TECHNICAL SERVICE BULLETIN

Technical Service Bulletin: 55-1793

Technical Service Bulletin Number 2024-01

Subject: Dynamax eGEN system and Daimler Sprinter 4-Cylinder and 6-Cylinder OEM Electrical system(s).

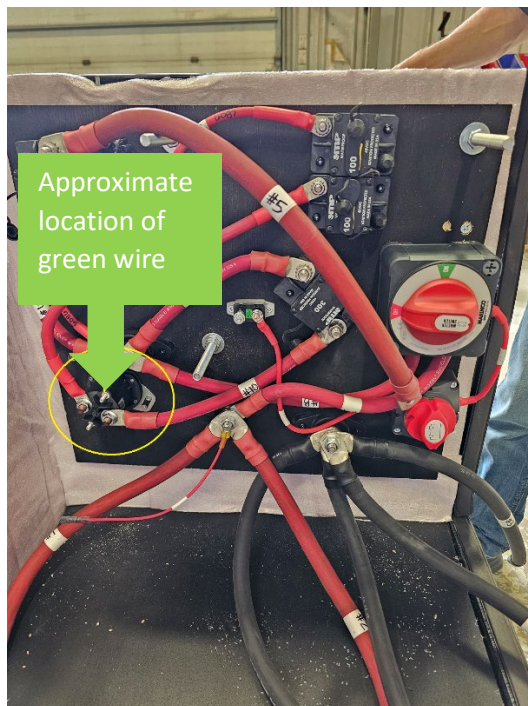
For production models (both 4-Cylinder and 6-Cylinder models) produced on or before April 1st, 2024) with the green wire still connected, follow the service procedure steps below to permanently disconnect (cut) the green wire and have shrink tubing added to both sides of this cut wire prevent possible reconnection.

By cutting this green wire, we are now fully separating our lithium system from the vehicle chassis electrical system which will prevent the any further OEM electrical system errors/fault codes from occurring. See the wiring diagram and photo(s) below for details.

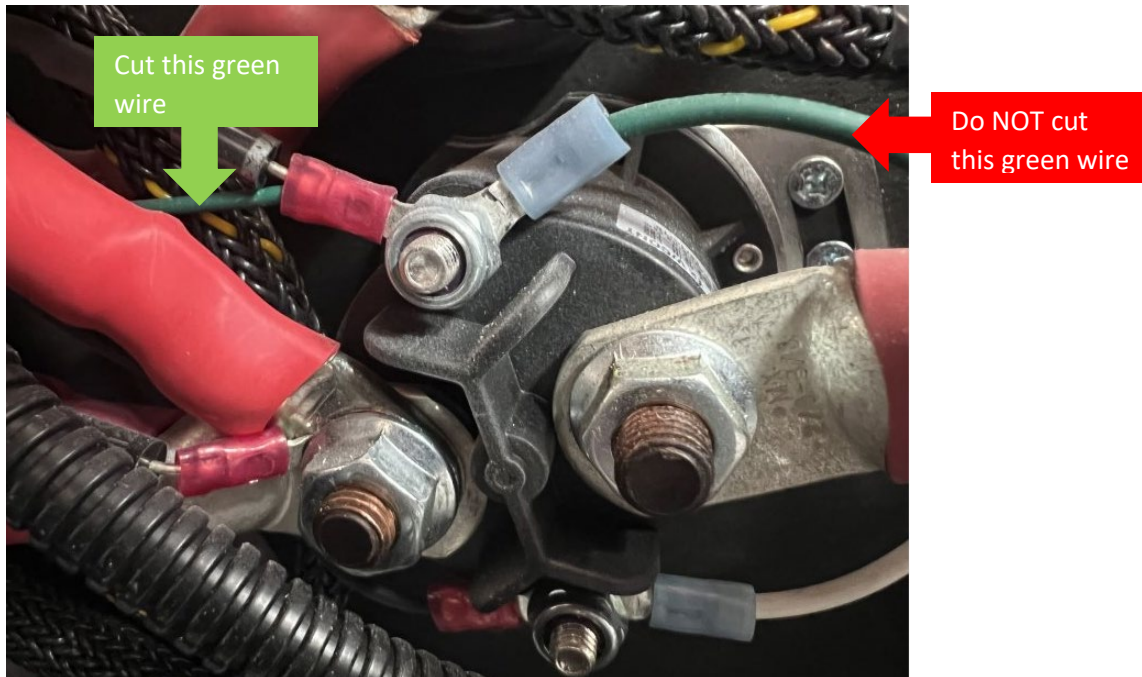
Step 2: Locate the solenoid / green wire on the wiring panel.

Step 3: Cut green wire indicated with the green arrow. Add heat shrink tubing to both ends of the cut green wire to protect cut ends to avoid reconnection. Process complete.
